**AGENDA
TOWN OF JUPITER
PLANNING AND ZONING COMMISSION REGULAR MEETING
COUNCIL CHAMBERS
TUESDAY, APRIL 14, 2026
7:00 PM**

**Bayside Office Building Site Plan Application
TOWN MANAGER'S OFFICE**

DATE: April 7, 2026
TO: Honorable Mayor and Members of Town Council
THRU: Frank Kitzerow, Town Manager
FROM: John Sickler, Director of Planning and Zoning **JS**
SUBJECT: **Bayside** - (quasi-judicial) – Site Plan application for a four story office building and shared access drive with an adjacent Town owned property, on a .53± acre property, located at 1001 North Alternate A1A (**PZ 22-5351**).

A2.02

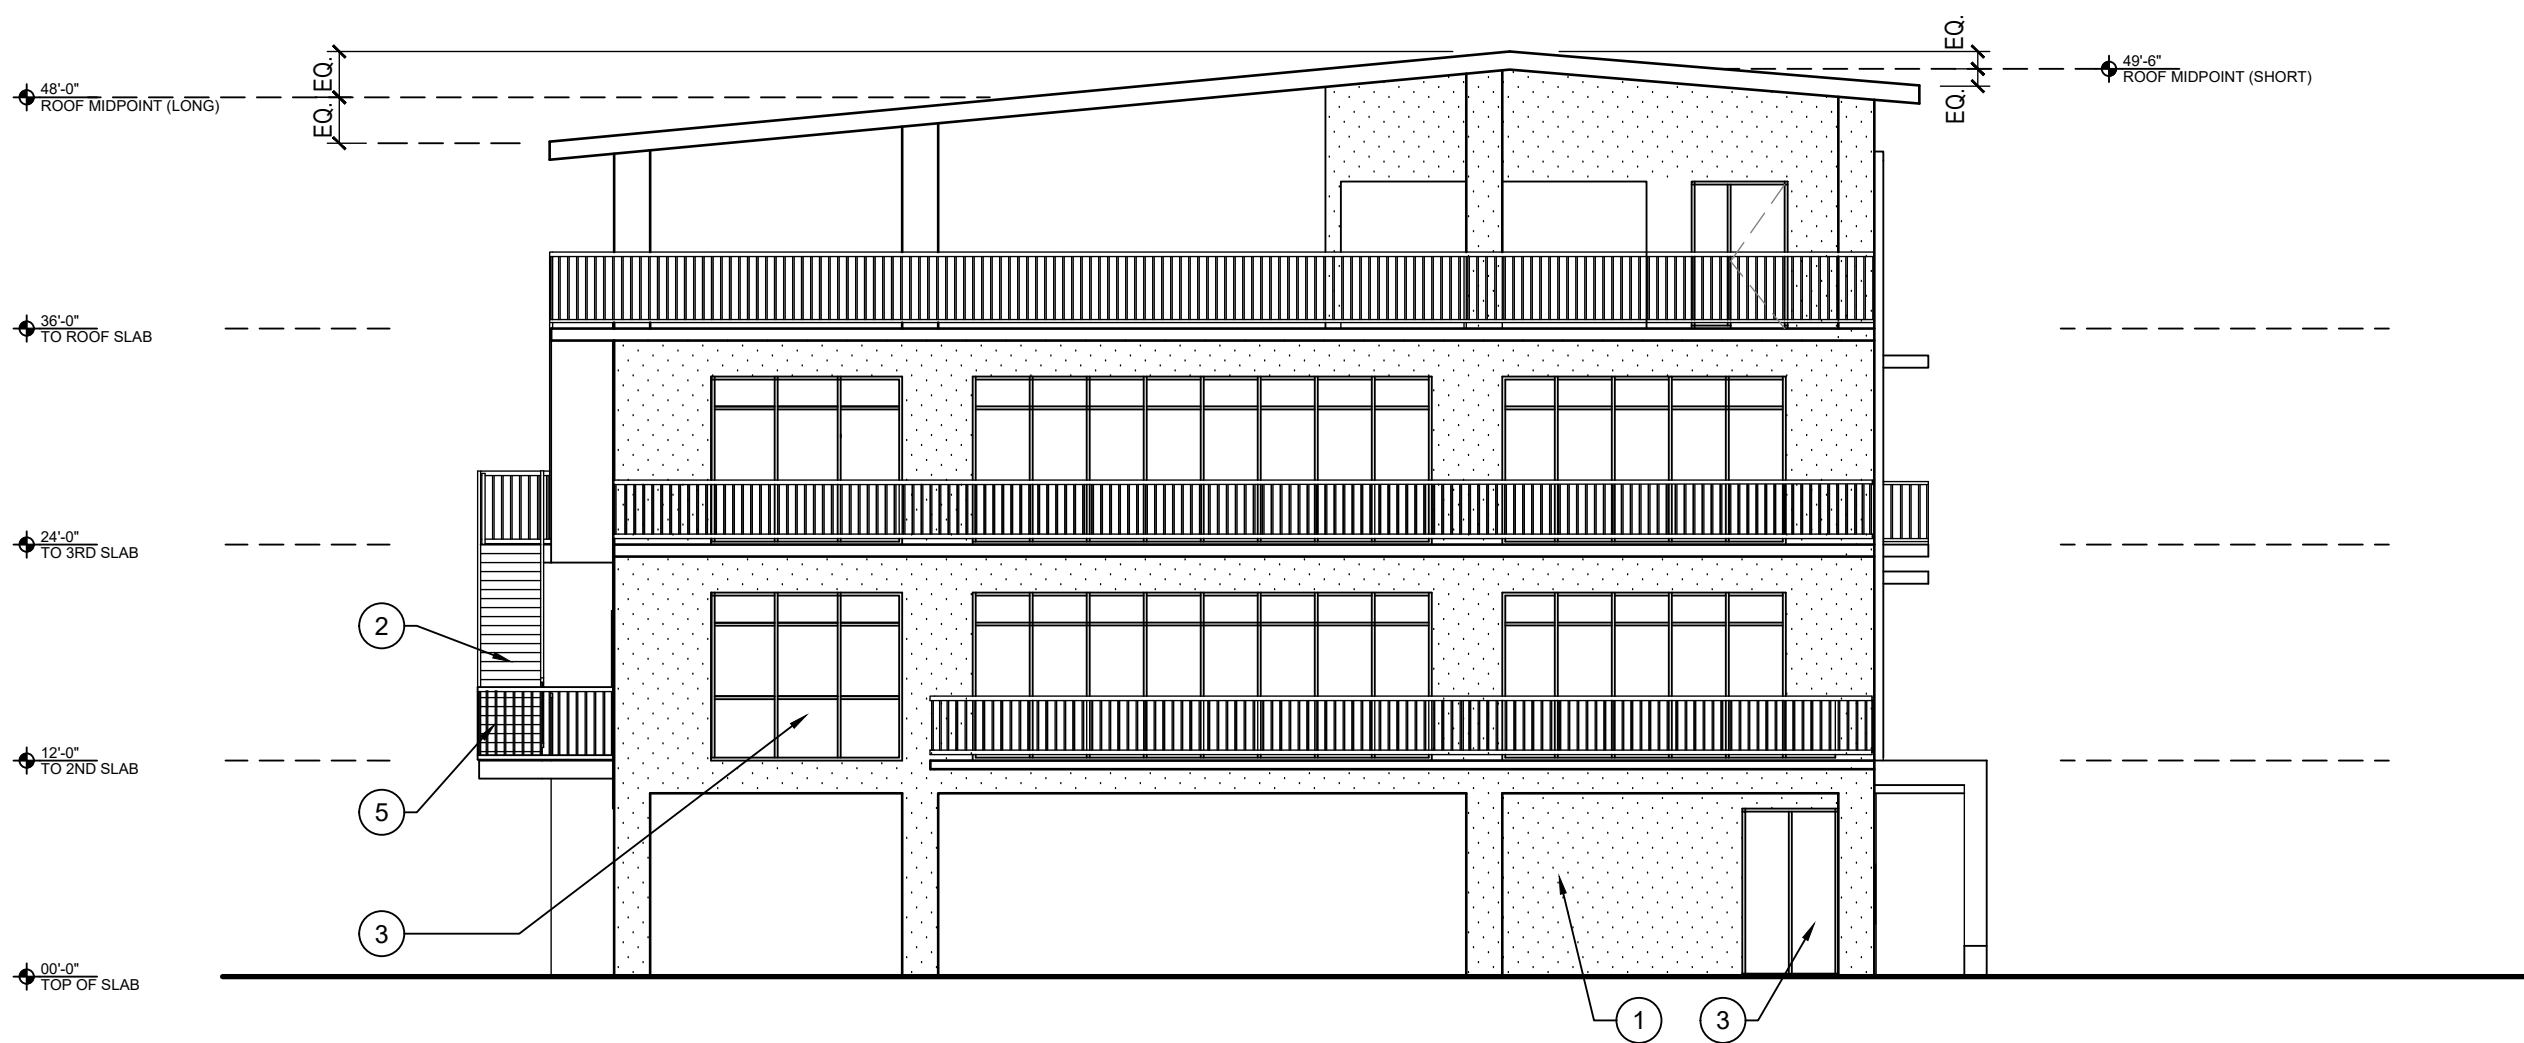
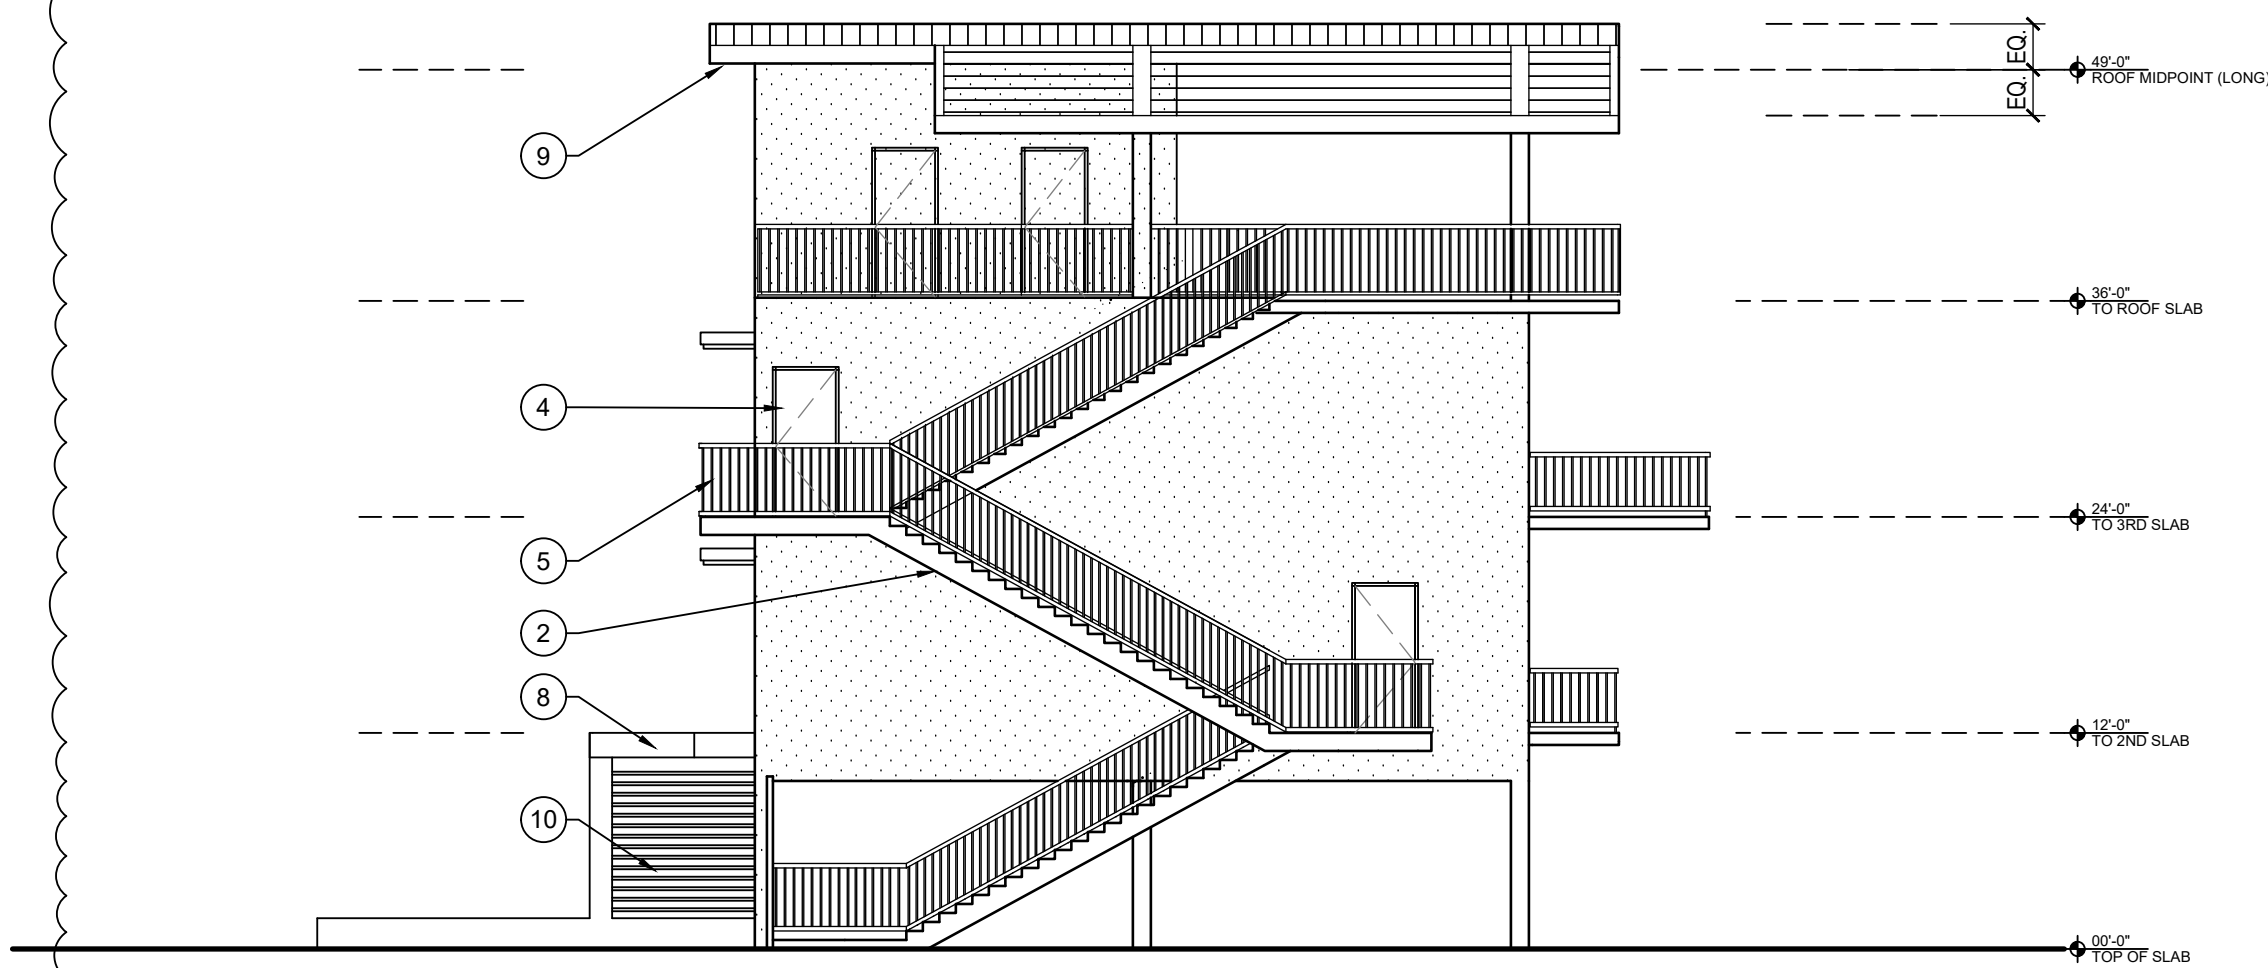
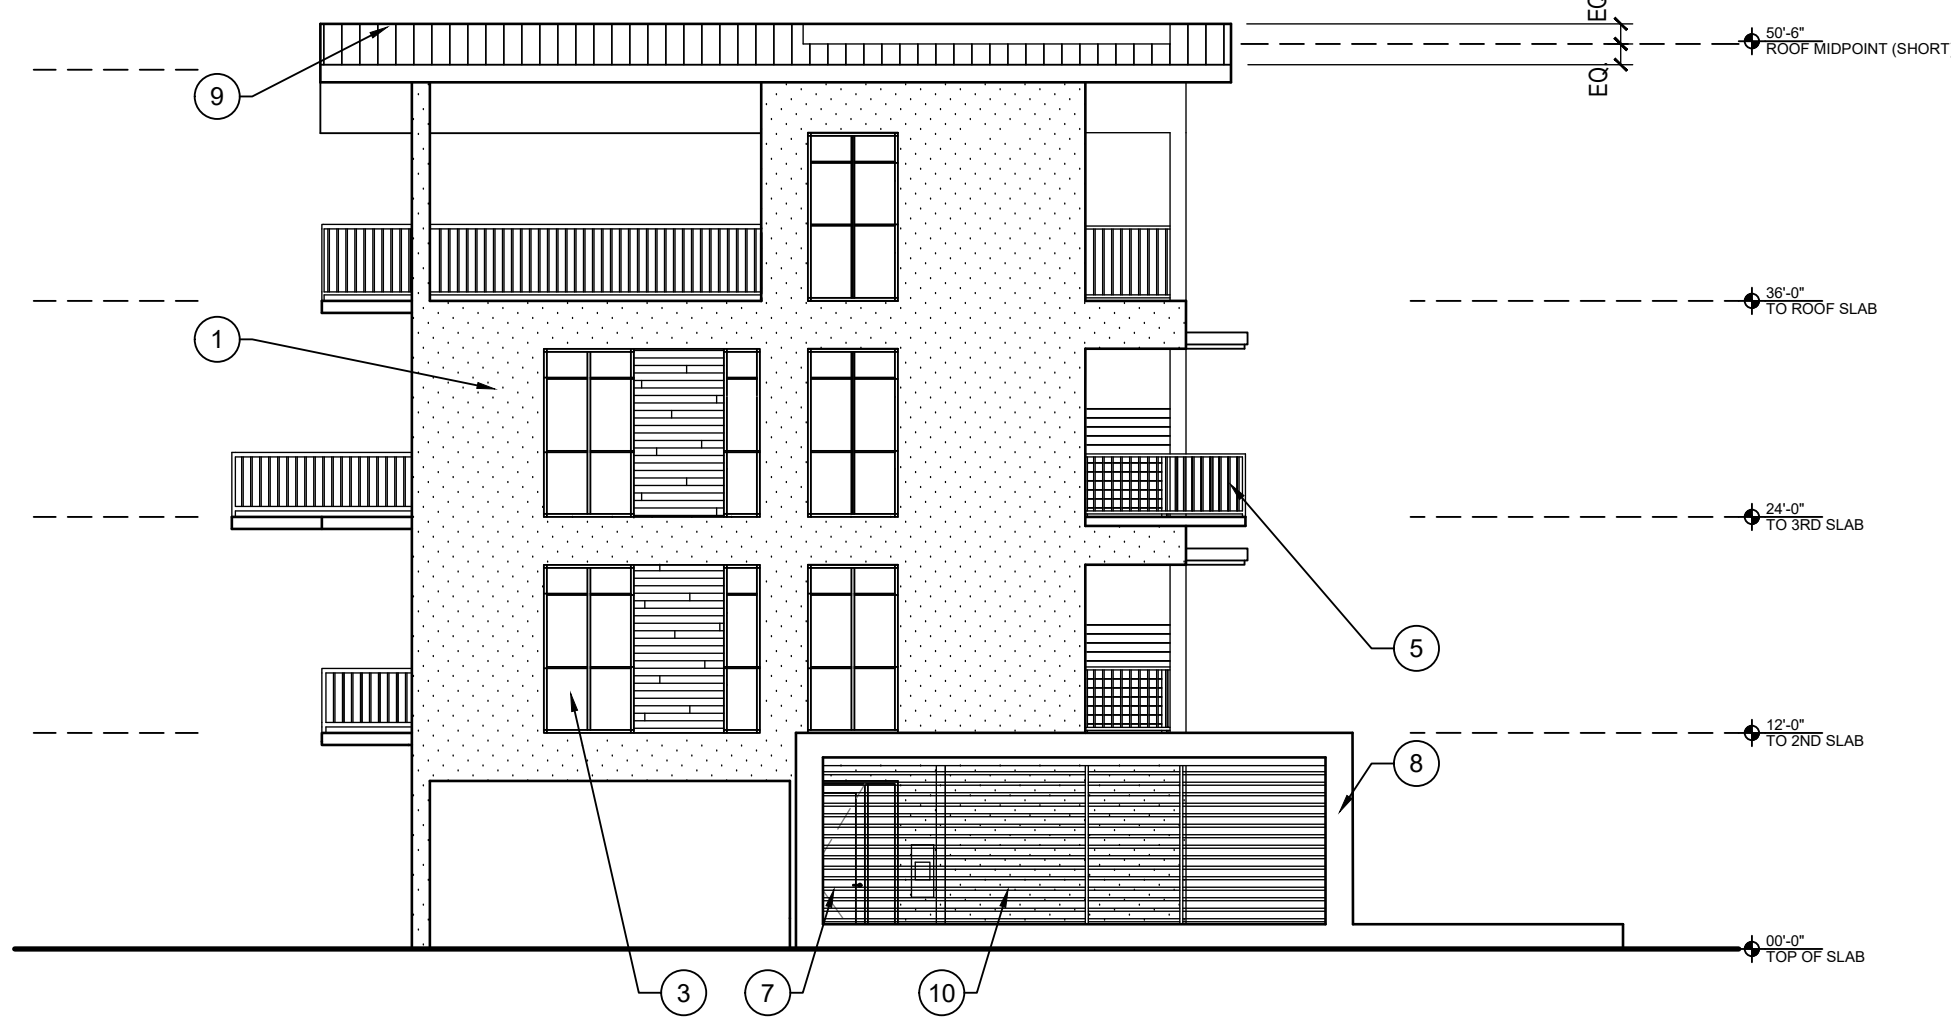
- Revise the architectural elevations to:
 - Address the massing of the fourth story;
 - Include a maintenance and management plan for the rooftop planters;
 - Include architectural details that interpret a historic style.

The development of the proposed office building is not consistent with the Comprehensive Plan policy listed above because of the buildings height, scale and massing. Architectural and design choices, specifically the tower and trellis on the top floor, and their location have contributed to the concern about the development's size and incompatibility with the surrounding developments. The proposed building is a four story, contemporary architectural style that should blend more with the historic commercial character of the surrounding area.
